Memorandum

Re: 103 Brick Church Road
SBL# 50.05-1-11.1

Date: May 3, 2024

Applicant's Concept

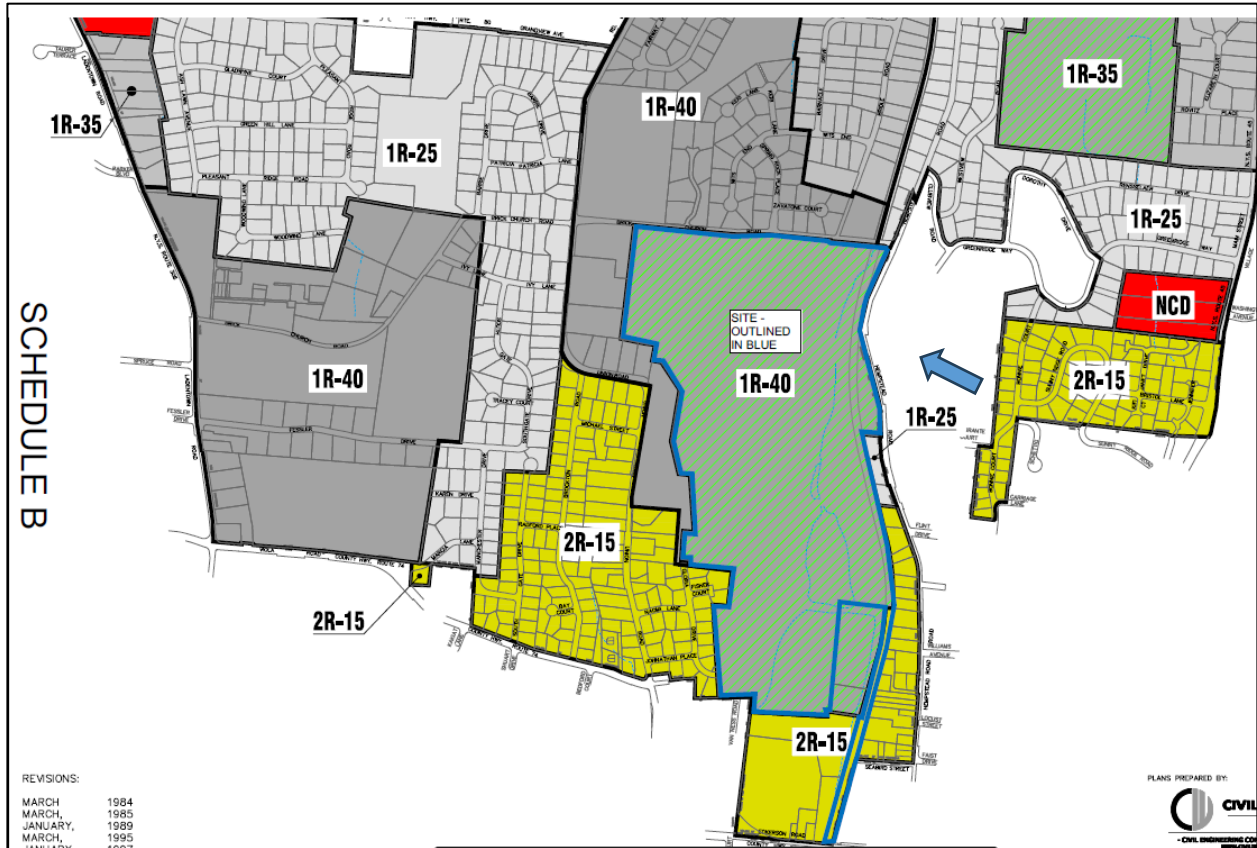
1. Relationship to Surrounding Zoning Districts. See the applicant’s diagram from Schedule B of the petition, which shows how the County Club site relates to the 2R-15 zoning district in New Hempstead, which wraps around the southern part of the site shown in yellow. **For full context, please show the areas zoned R-25 and R-15 east of the site within the Town of Ramapo Hillcrest neighborhood** (see blue arrow) which is now shown only as a white space.

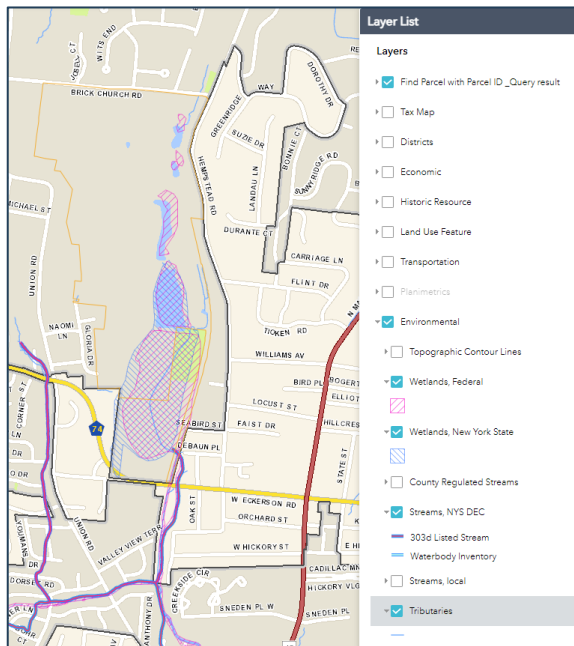
3. **Feasibility of Unit Count.** We note that on the eastern side of the site, ponds, wetlands, and streams may constrain the predicted number of 10,000 square foot lots that the site may yield. **The applicant may wish to consider the implications of the following constraints, which may lower the potential unit count below the desired level of 325 single-family homes:**

a. **Federal and State Wetland Constraints.** Along the Hempstead Road side of the site, there is a string of federal wetlands. **Below the largest pond, there is a sizeable 42.3-acre State DEC classified wetland (#TH-19).** State regulations mandate a 100-foot buffer around state classified wetlands where a state permit is required for any disturbance. Federal wetlands do not require any federally mandated buffer. However, for adjacent work or disturbance to both state and federal wetlands, a wetlands permit is required by the Village of New Hempstead Code Chapter 159, Freshwater Wetlands. See the output from the Rockland County GIS system at left. We would recommend that lot boundaries be adjusted so that owners will not have house sites with the State’s jurisdictional wetlands buffers.

b. **Pascack Brook and Tributary.** The State DEC wetland contains a tributary that feeds into Pascack Brook, a county-regulated stream. The applicant should investigate whether the RC Drainage Agency regulations will constrain any proposed lots at the southeastern corner of the site.

c. Floodplain Constraints. **The wetlands and pond area are also surrounded by a mapped FEMA 100-year floodplain.** It would be advisable not to create any new house lots that contain federal floodplains. See Chapter 154, Flood Damage Prevention, and figure at right for floodplain location:
